PROJECT NAME: IN076 ICTC– REPLACE BACKUP CHILLER & UPS UNITS
OWNER NAME: INDIANA UNIVERSITY
IU PROJECT NO. 20231522 / CES PROJECT NO. 2024-007.ICT
ADDENDUM NO. 2
DATED: NOVEMBER 26, 2024

A. Drawing Number EP101

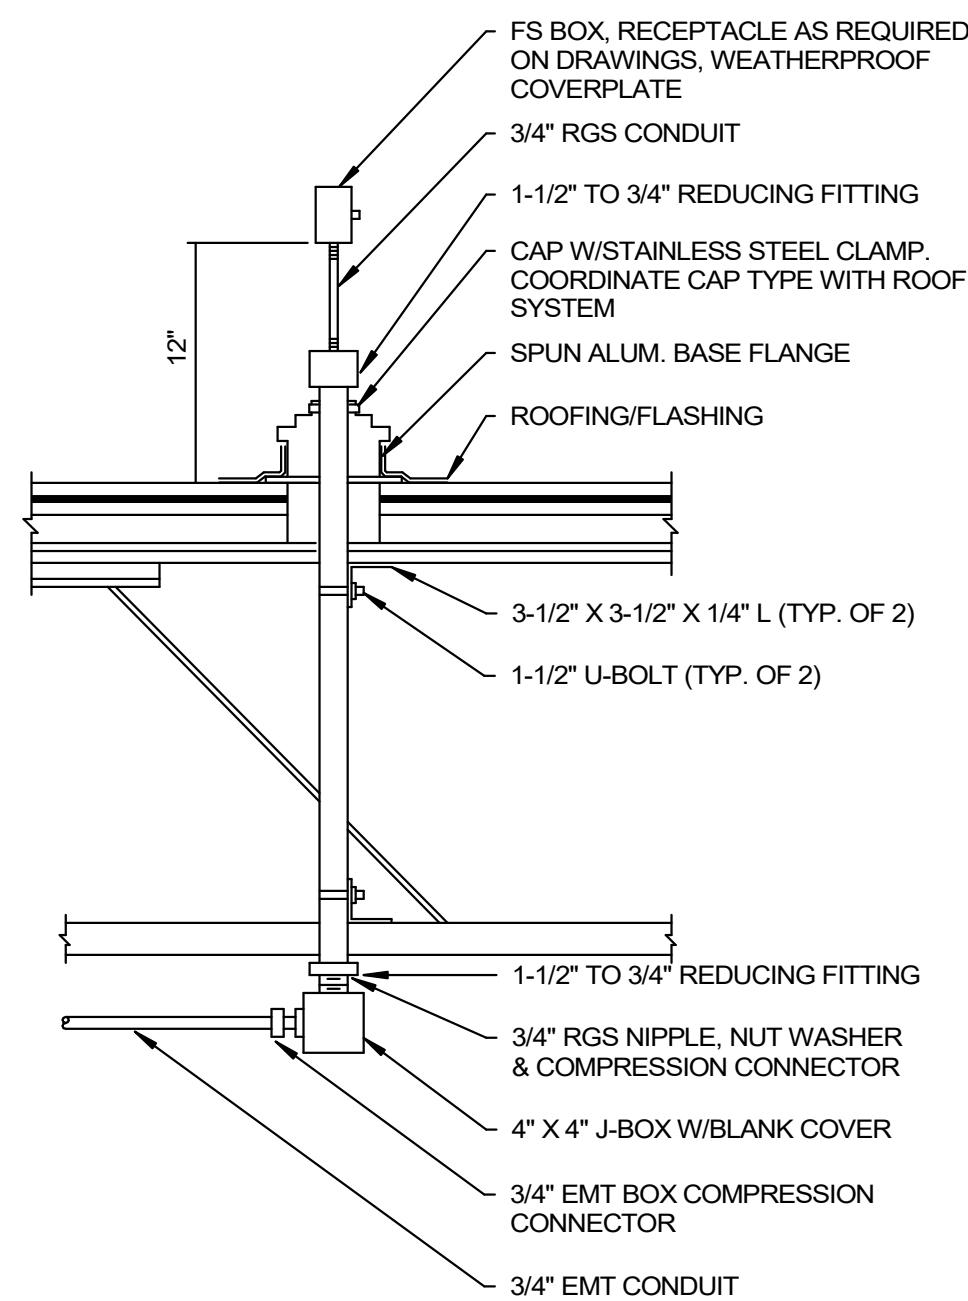
1. DELETE AND REPLACE Drawing in its entirety.

Added general note to coordinate with Schneider Electric and provide a complete and operational system.

- COORDINATE WITH SCHNEIDER ELECTRIC THE INTEGRATION OF THIS PROJECT WITH EPMS AT BLOOMINGTON. PROVIDE ALL NECESSARY HARDWARE, INSTALLATION, SOFTWARE MODIFICATIONS, AND UPDATE ALL EXISTING SYSTEM DRAWINGS IN BID.
